DEADLINE 4 REPRESENTATIONS REGARDING THE APPLICATION BY SUFFOLK COUNTY COUNCIL FOR AN ORDER GRANTING DEVELOPMENT CONSENT FOR THE LAKE LOTHING THIRD CROSSING

PLANNING INSPECTORATE REFERENCE NUMBER TR010023

Lake Lothing Third Crossing

Commentary on Suffolk County Council proposals January 2019

Ref SCC drawing 1069948-SCC-HGBN-LL-DR-KK-0006 rev P01, dated 24-01-2019

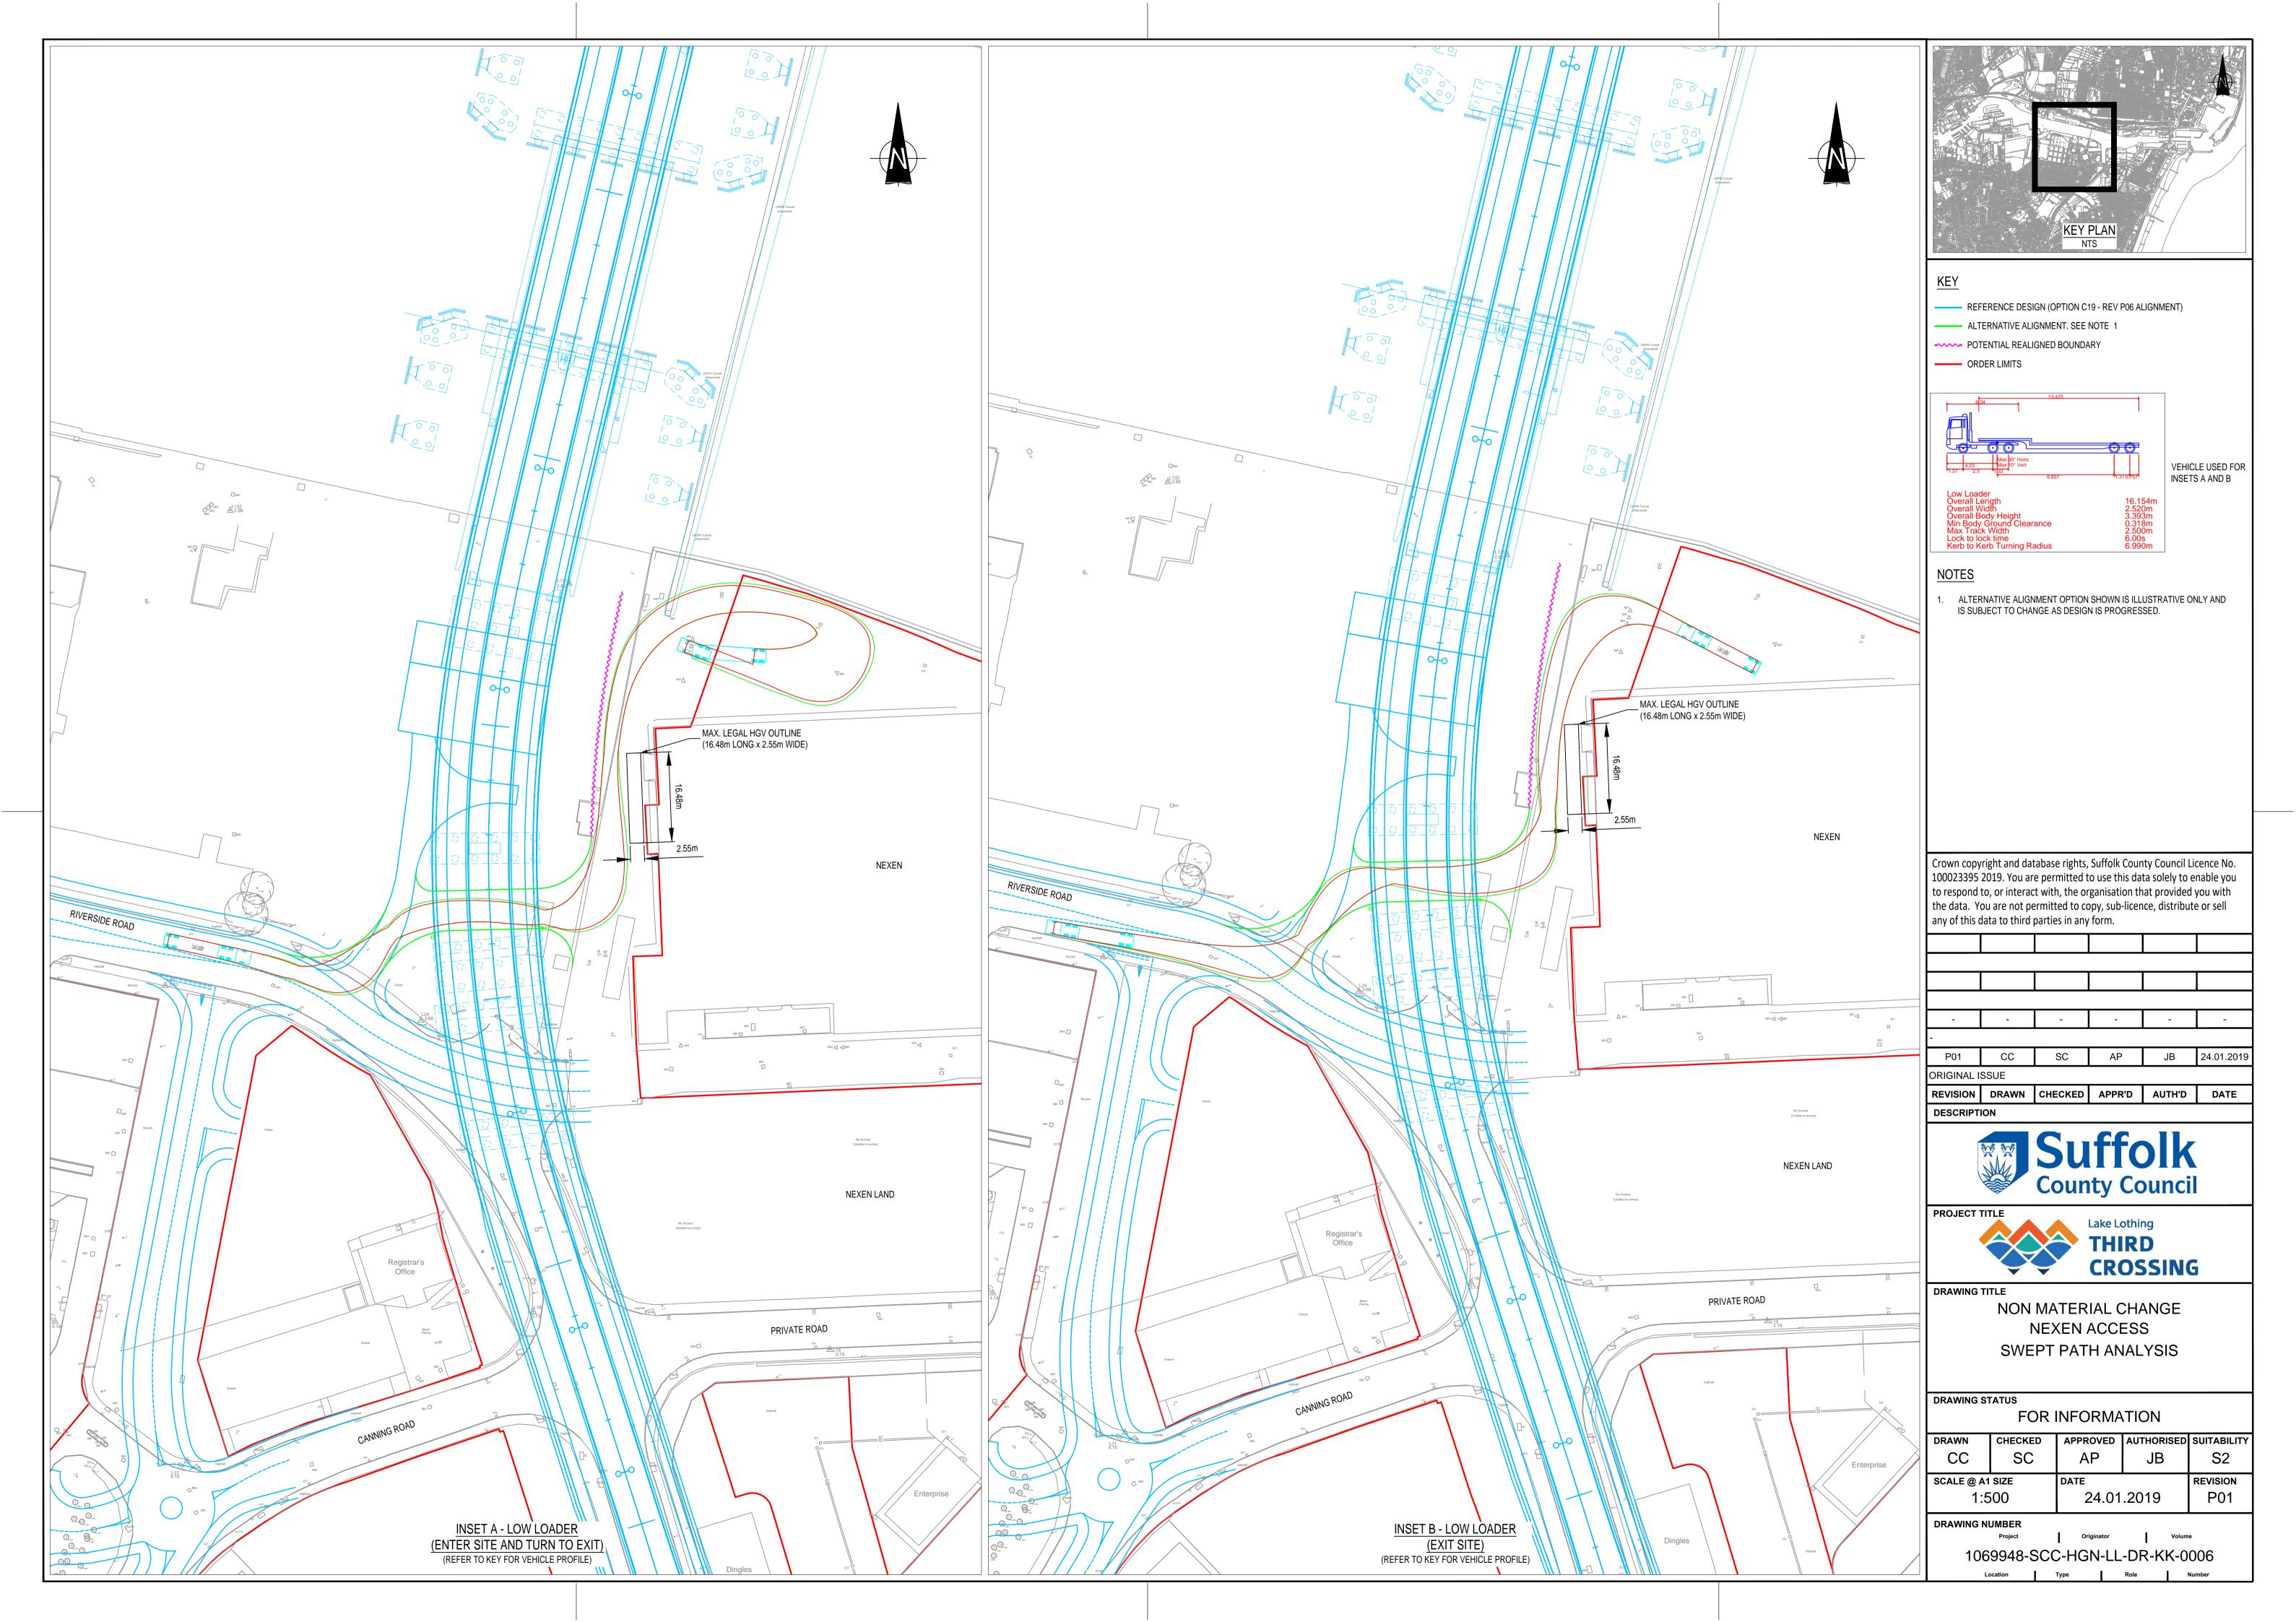
- 1 The drawing provides an alternative access arrangement for heavy goods vehicles to enter and leave the Nexen site. This has been provided in response to report by Mayer Brown, 'Impact on Access and Operations Report 2' dated 8th January 2019.

- The new access proposal indicates a route that is to the north of the existing Nexen access. It is provided through the next clear span of the LLTC bridge structure (between Abutment 1 and Pier 2). It is noted that an earlier proposal from SCC (Oct 2018) provided an alternative heavy goods vehicle access through a span further north than this (north of Pier 2).

- 3 The proposed access arrangement continues to bring hgvs on to the Nexen site in close proximity to the principal 'goods in' door on the west frontage of the factory. The drawing illustrates the swept path tracking of a low-loader entering and leaving the site whilst a 16.5m articulated vehicle is parked at the goods in door.

- 4 The drawing illustrates that land outside of the Nexen property is required for the roadway to accommodate the vehicle manoeuvre described at 3 above.

- 5 The following observations are made in connection with the access road proposal:
 - a] The vehicles entering and leaving the site have to negotiate a 'pinch-point' at the 'goods-in door when a vehicle is parked up for delivery / unloading. This could lead to obstruction if the delivery vehicle is not parked up precisely.

- b] Operatives working on the ground close to a parked-up delivery vehicle are at risk from the movement of other vehicles entering or leaving the site.

- c] The headroom afforded to heavy goods vehicles entering / leaving site is less than that afforded by the earlier SCC proposal (Oct 2018); c.6.5m c/w 7.0m.

- Taking account of the above, my views on the adequacy or otherwise of the latest proposal are as follow: -
 - A] Although the current operation of the Nexen site does also require vehicles entering the site to pass a vehicle unloading at the goods inward door, the latest proposal from SCC misses an opportunity to provide for an improved access arrangement in terms of both safety and operational capacity.

- B] The latest proposal illustrates some additional land that could be made available to Nexen to accommodate a new access route. However, the extent of land shown as being made available appears to be somewhat insufficient to safely accommodate the vehicle manoeuvres. It would appear that a wider strip of land to the west of Nexen could be provided to increase the roadway width for vehicles entering and leaving the site.

- The solution provided has the appearance of being the minimum possible, rather than providing a proper assessment of safety and operation.
- C] My Report 2 on access to Nexen provided a drawing of an alternative access to the property; the route passing to the west of the LLTC control tower and then turning along the south quay to enter the property on its northern boundary. This route allows the heavy vehicles to be kept away from the factory doors and thereby to reduce to a minimum the risk of obstruction or hindrance of factory operations.

- There has been no apparent consideration given by SCC to this alternative route.
- D] The latest proposal illustrates a vehicle route passing through a span of the LLTC bridge structure with less headroom than that of an earlier proposal from SCC. It is not obvious why this route with lesser headroom has now been used. A route with increased vehicle headroom would better accommodate the movement of large and over-height vehicles that are transported from the Nexen site.
